**SECTION 000001 – ADDENDUM NUMBER 2**

**DATE: DECEMBER 8, 2025**

**RE: DCU CENTER ELEVATOR RENOVATION  
50 FOSTER STREET, WORCESTER, MA 01608**

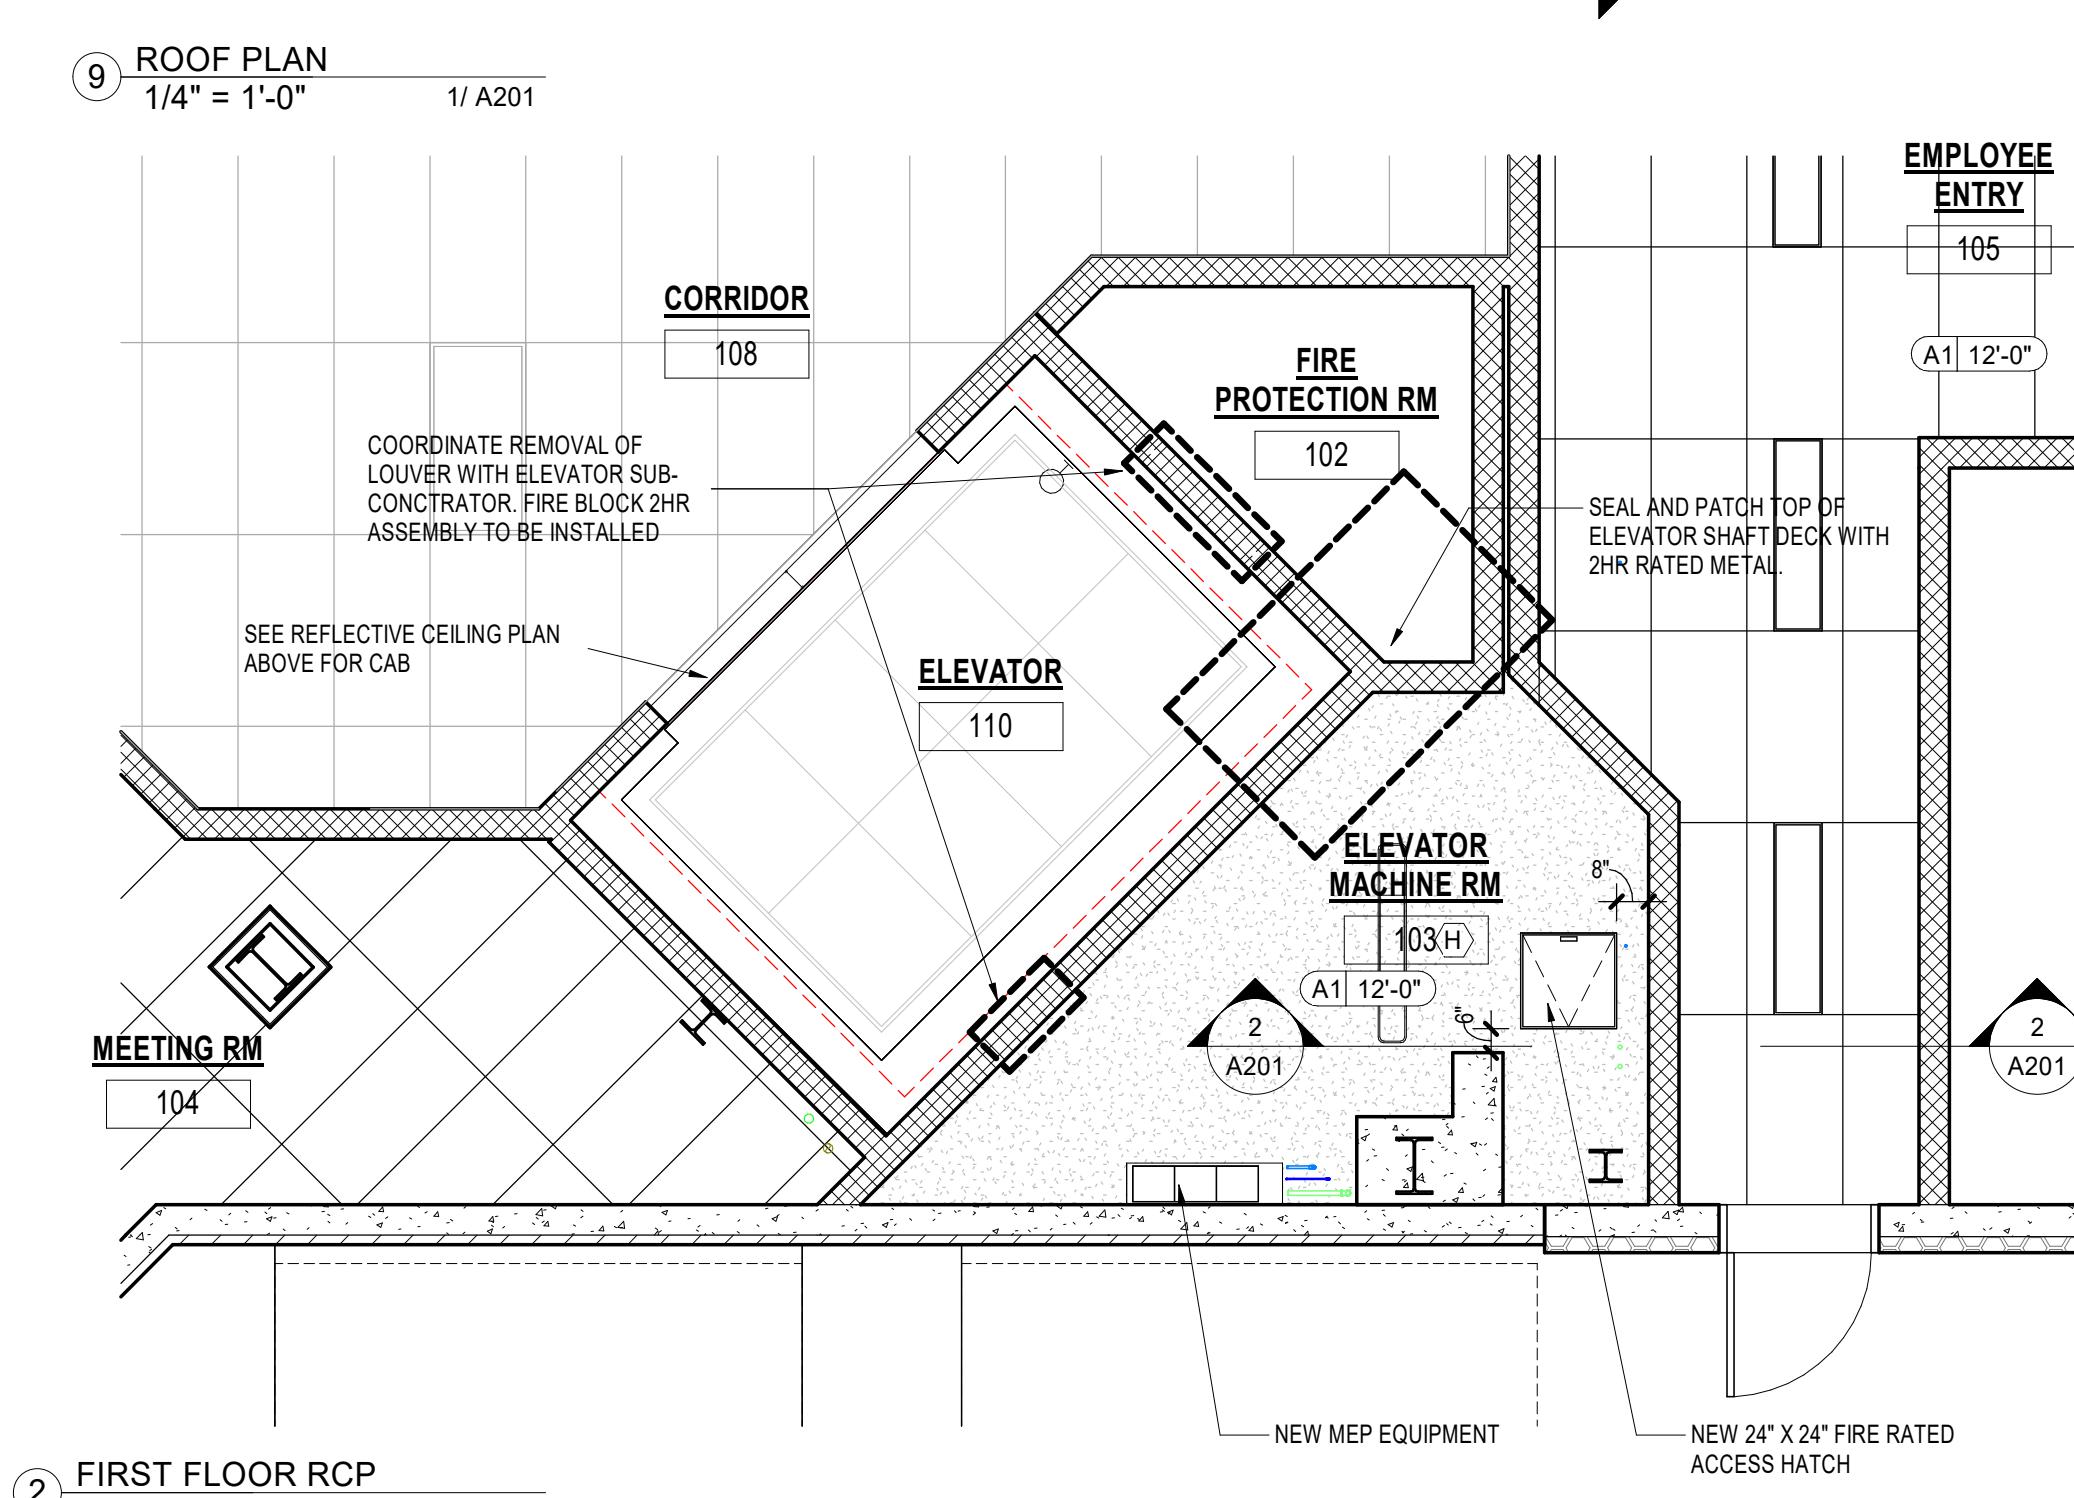
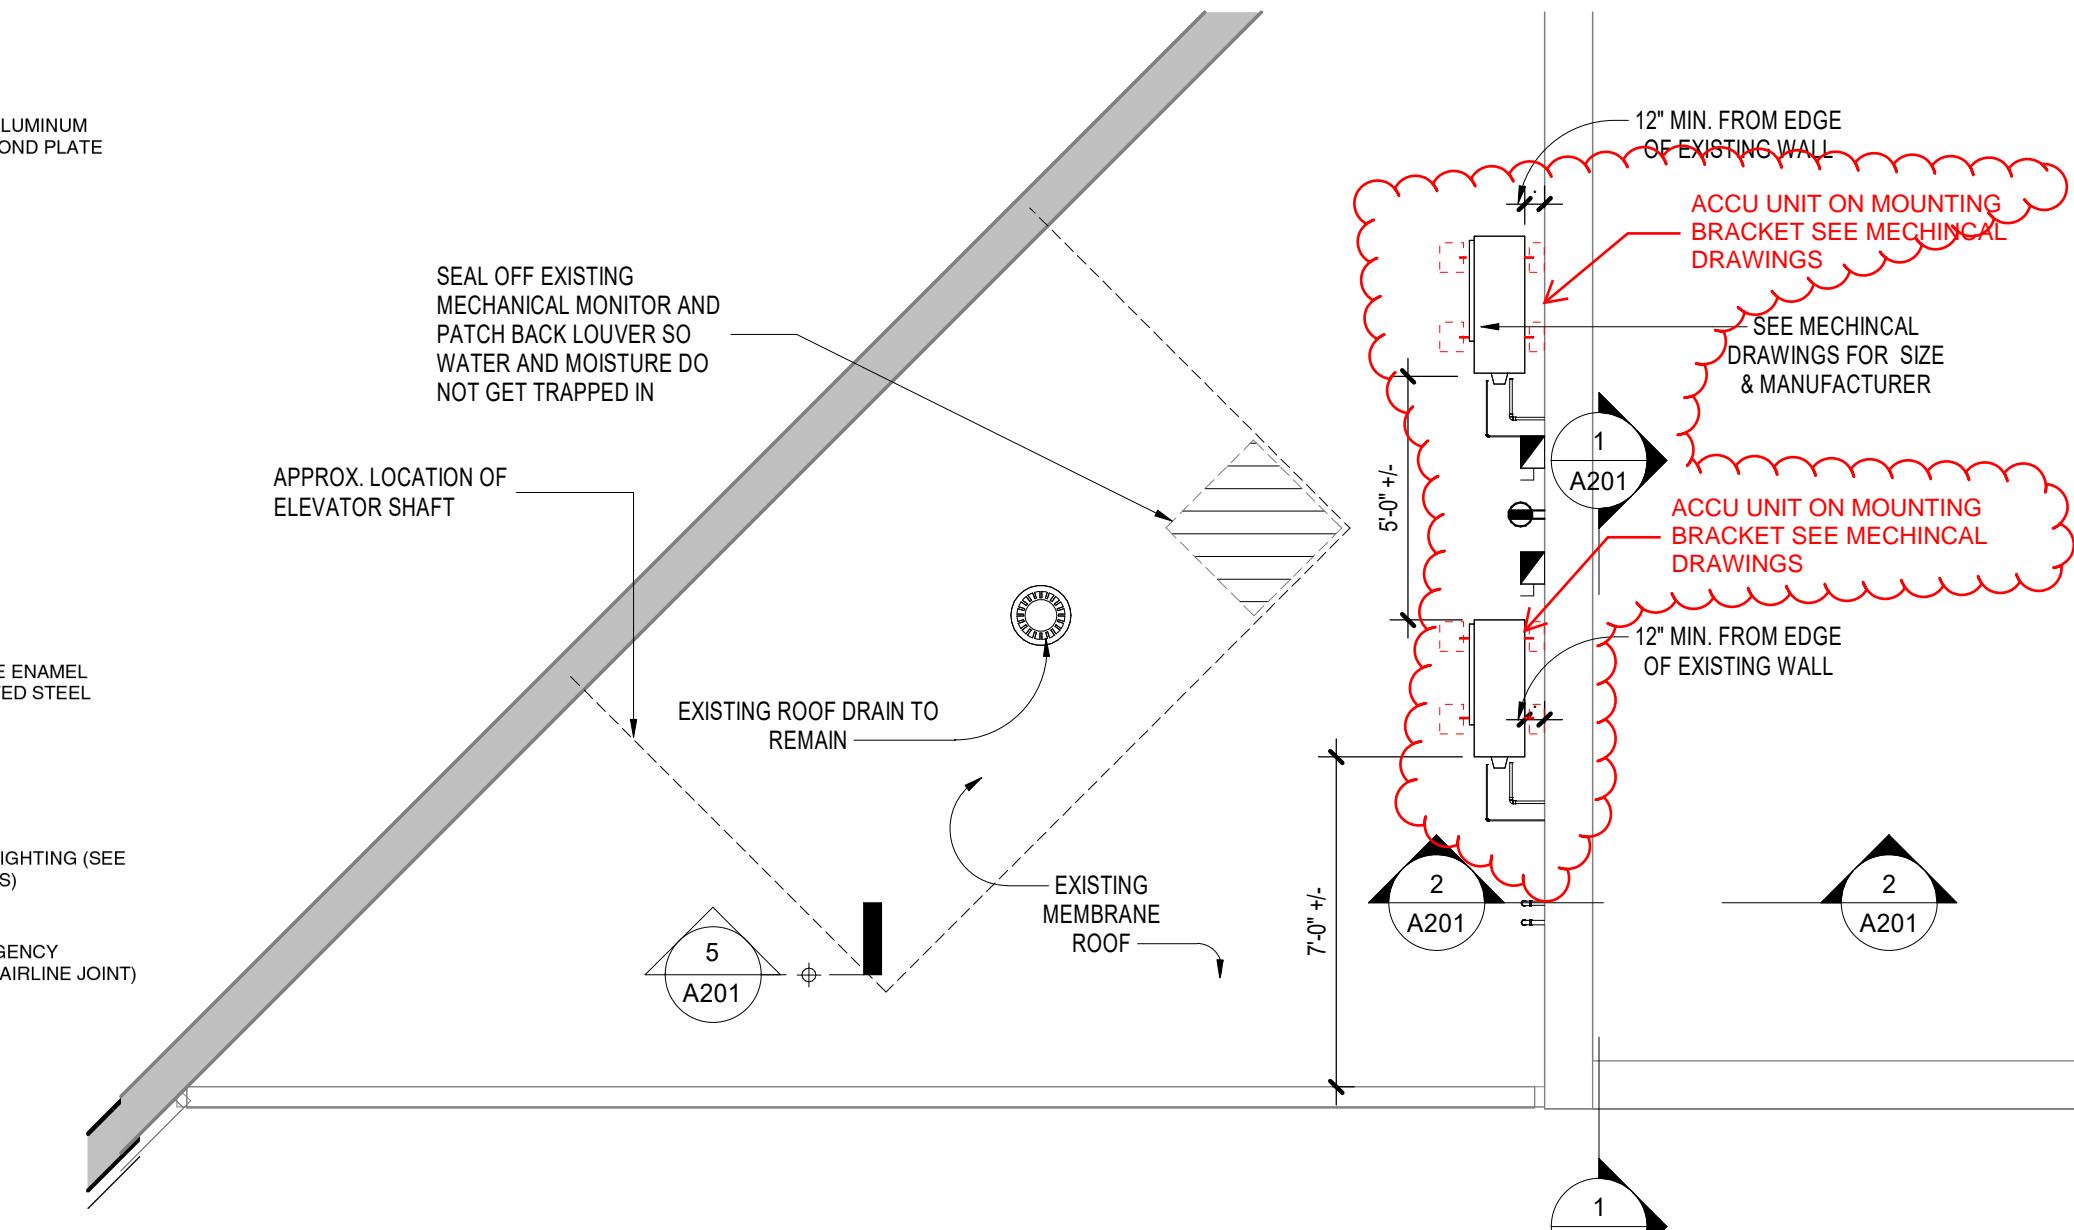
**4.1** **Question:** Details 1 & 2 On A201 shows the route of travel for the new lines for the MEP equipment up to the roof. Please provide scope of work as to how we access the wall cavity space and then close it up.  
**Response:** New lines will be routed through the Storage Room and daylight on the flat EPDM roof and terminated on a pitch pocket. Please refer to attached reissued drawings.

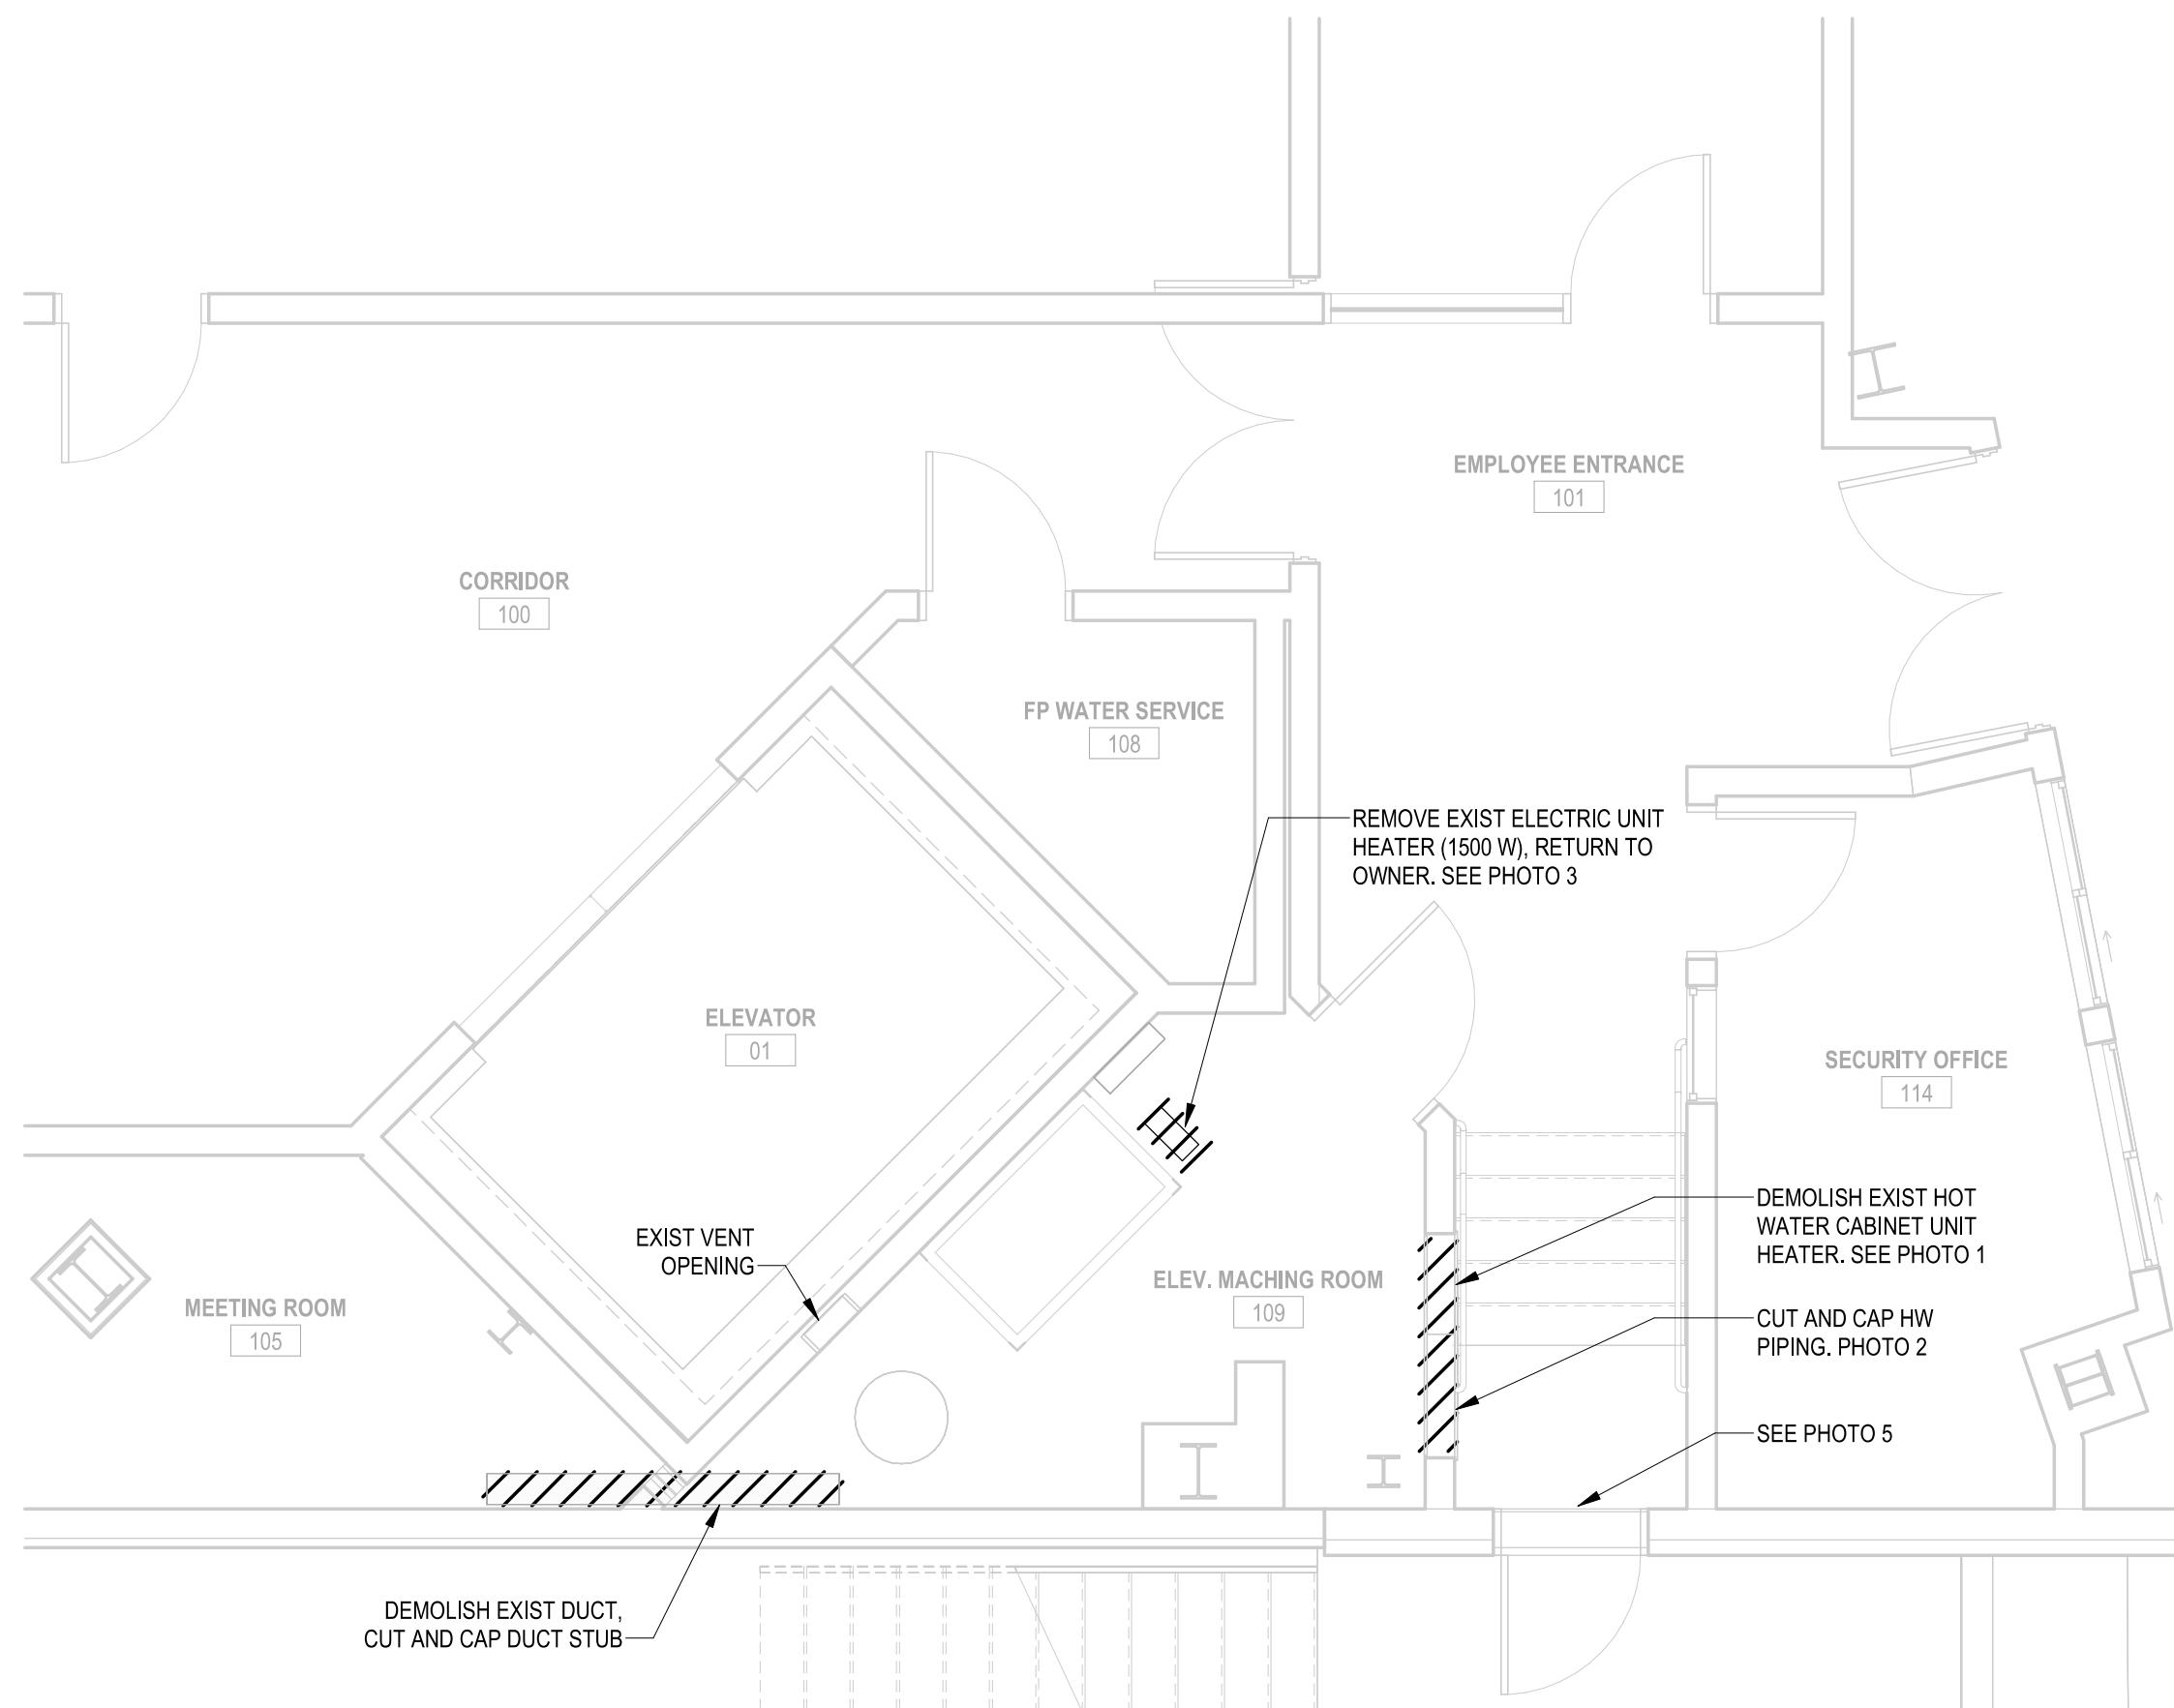
**4.3** **Question:** Detail 3 on H101 shows mounting the ACCU's on wall support brackets. Please provide scope of work needed to prepare an adequate support surface to mount on.  
**Response:** ACCU's to be mounted on prefabricated stand 18" high above roof membrane. ACCU unit shall be bolted to supports to withstand wind and seismic loads. Please refer to attached reissued drawings.
